TRANS/WP.29/GRSP/2000/9/Add.1
8 February 2001

PROPOSAL FOR DRAFT AMENDMENTS TO REGULATION No. 14
(Safety-belt anchorages)

Addendum 1

Transmitted by the Expert from the International Organization of
Motor Vehicles Manufacturers (OICA)

Figure 1

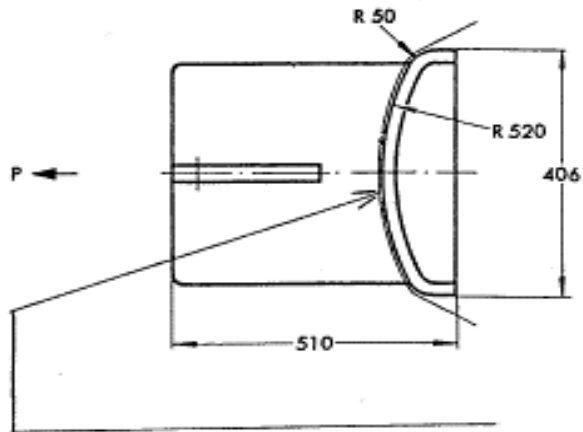
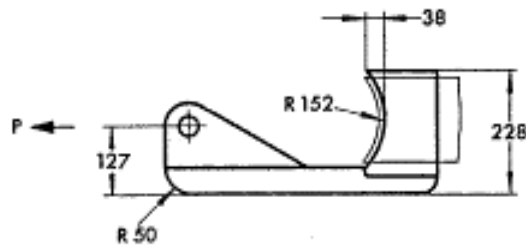
Annex 3, amend to read:
